REVISED NOTICE OF A TYPE II DECISION ON A PROPOSAL IN YOUR NEIGHBORHOOD

CASE FILE NUMBER: LU 17-156087 DZM - FAILING MIXED USE DEVELOPMENT

PROPOSAL:
 The applicants are seeking Design Review Approval for a 65'-4 1/2" tall, 5 story mixed use building located at the north-east corner of N Vancouver Avenue and NE Failing Street. The

C-49

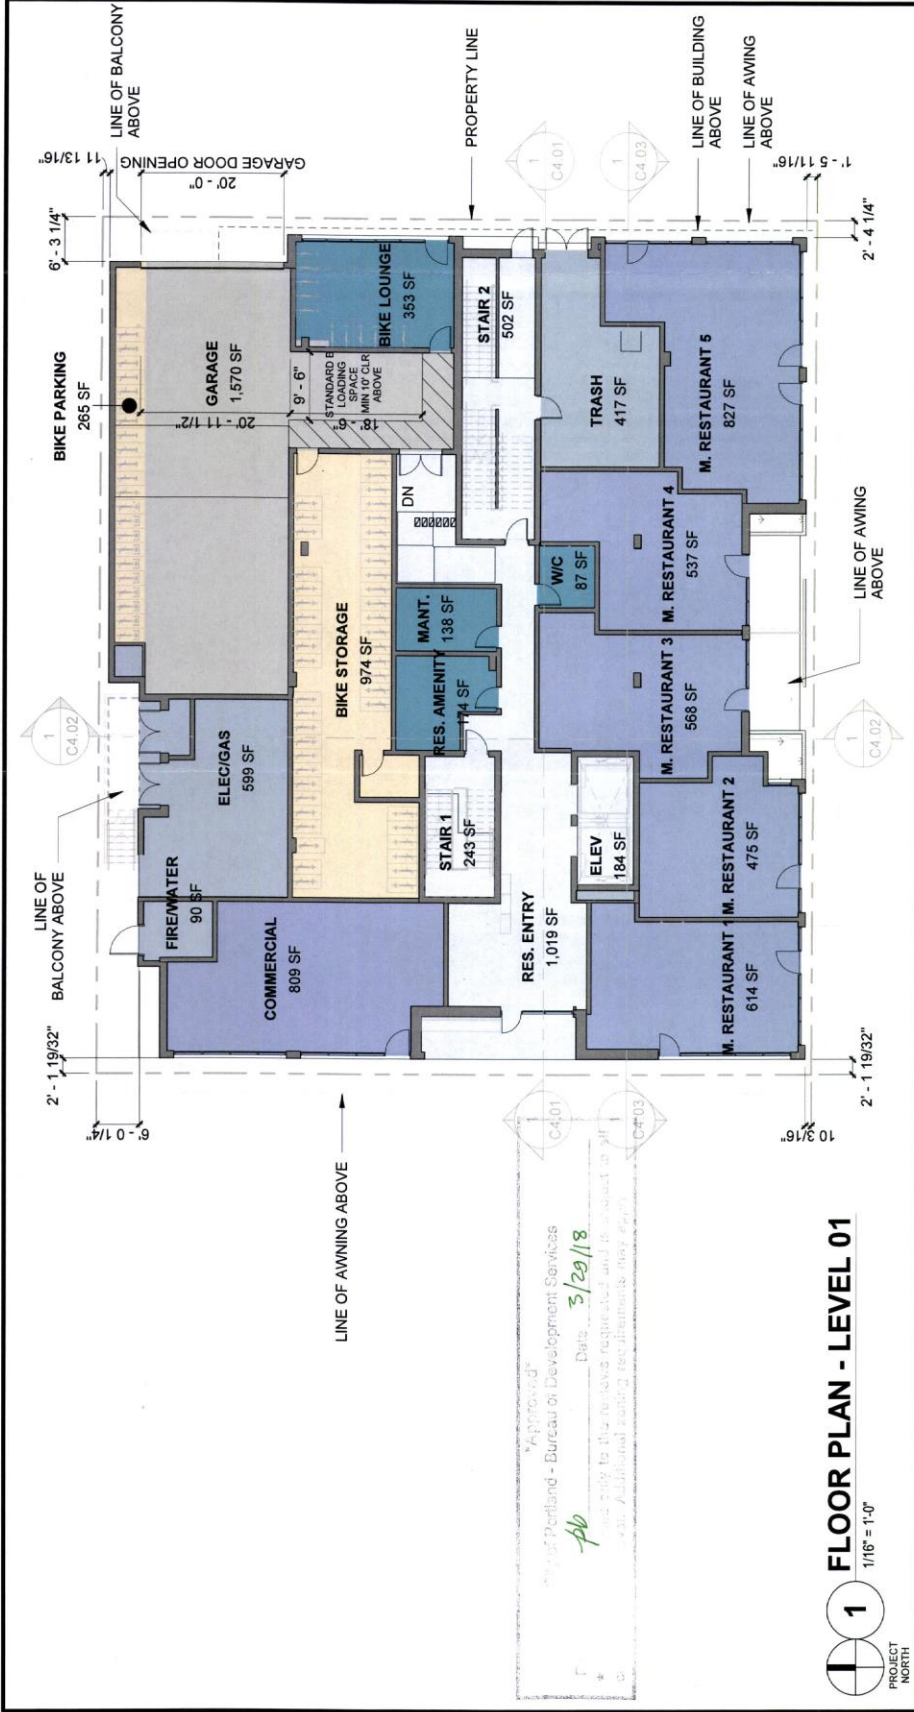
NOTE: THIS IS A REVISED DECISION. CHANGES FROM THE PREVIOUS DECISION, DATED DECEMBER 14, 2017 ARE UNDERLINED.

Approved, per the approved site plans, Exhibits C-1 through C-48, signed and dated 12/12/17, and C49, signed and dated 3/29/18 subject to the following conditions:
